ADDENDUM No. ONE

Date: January 13, 2025

Project: Pembroke 2024 LMIG, MES No. 2024-15

PAVEMENT OVERLAY EXHIBIT

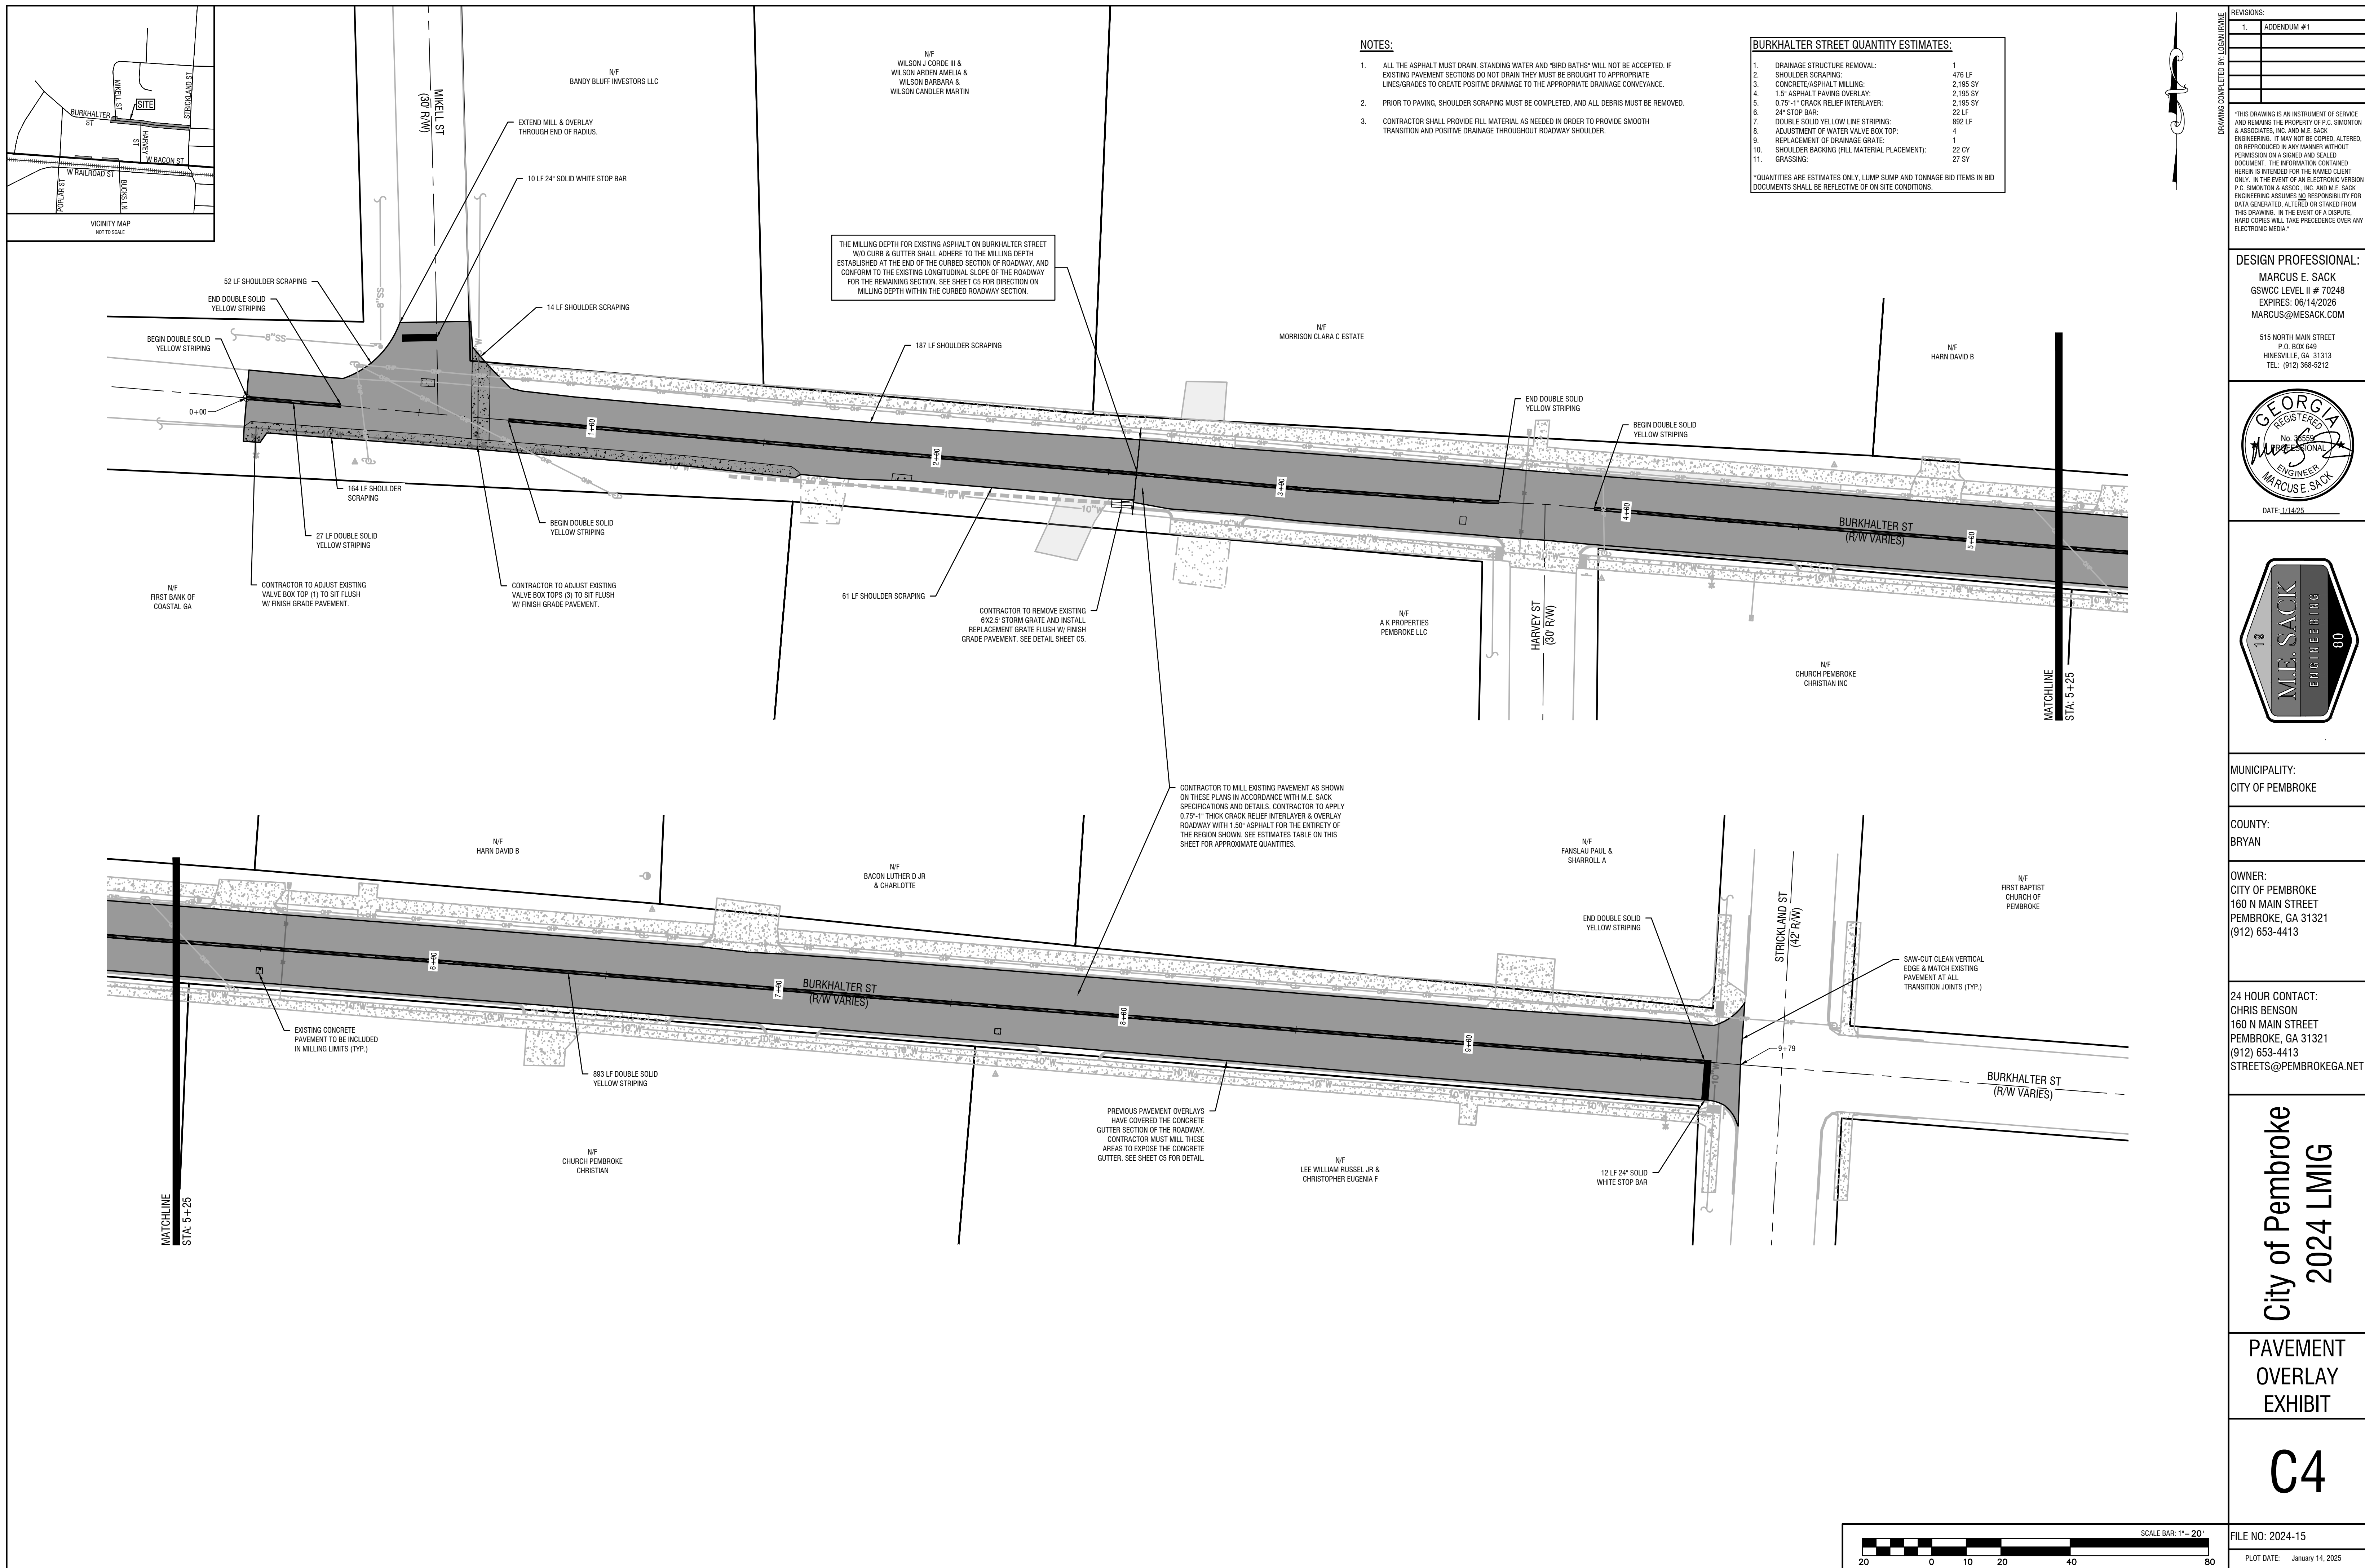
- Replace the original sheets C4 and C5 with the enclosed of the same. Note the quantity estimates and language regarding Concrete Pavement Removal and 8" Granular Roadway Base have been revised on sheet C4, information specifically relating to milling depth for the section of roadway with no curb and gutter has been included on sheet C4, and the "Overlay Asphalt and Conform to Existing Curb and Gutter" detail on sheet C5 has been revised to provide

2. *Is milling through the concrete pavement patches within the roadway acceptable?*
 - Yes. The existing concrete pavement patches can be milled to the same depth as the surrounding asphalt pavement. Note that this will only apply to milling performed on Burkhalter Street (see Sheet C4). As a result, Concrete Pavement Removal and 8" Granular Roadway Base have been removed from the Bid Form.

OVERLAY ASPHALT CONFORM TO EXISTING CURB & GUTTER DETAIL
NOT TO SCALE

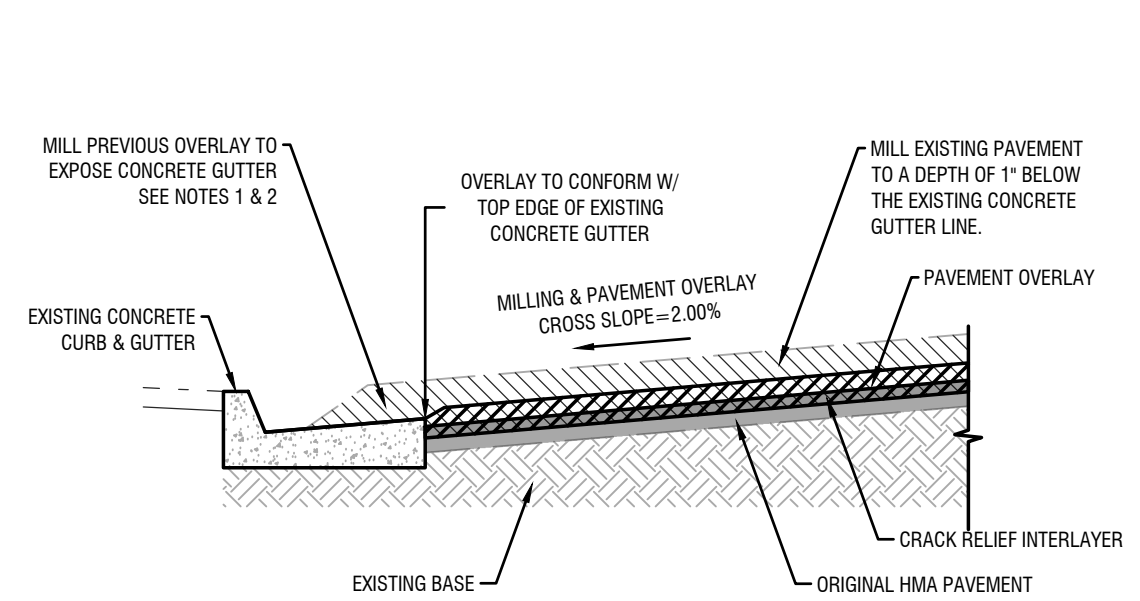
detailed direction on the milling and overlay procedure for the curbed portion of Burkhalter Street.

3. *What is the depth of milling on Burkhalter Street?*
 - The milling depth along Burkhalter Street will vary depending on the true depth of the existing concrete gutter. Contractors will need to mill down to the original concrete gutters before milling and additional 1" below the top edge of the concrete gutter in the travel lane portion of the roadway. See Sheet C5 for full details on milling in these areas.

- NOTES:**
1. CONTRACTOR TO MILL EXISTING PAVEMENT DOWN TO THE DEPTH OF THE ORIGINAL CONCRETE GUTTER SECTION, FOLLOWED BY ADDITIONAL MILLING OF THE TRAVEL LANE TO A DEPTH OF 1" BELOW THE TOP EDGE OF THE EXISTING CONCRETE GUTTER LINE.
 2. CONTRACTOR SHALL USE MINI MILLING MACHINE WHEN MILLING ABOVE/AROUND THE CONCRETE GUTTER SECTIONS TO MINIMIZE IMPACT TO THE ORIGINAL CONCRETE.
 3. PROPOSED OVERLAY IS TO BE APPLIED WITH A 2.00% CROSS SLOPE. EXISTING PAVEMENT IS TO BE MILLED AT THE EQUIVALENT CROSS SLOPE TO ALLOW FOR CONSISTENT OVERLAY APPLICATION.
 4. SEE OVERLAY DETAILS FOR TYPE OF PAVEMENT & OVERLAY DEPTH REQUIRED.
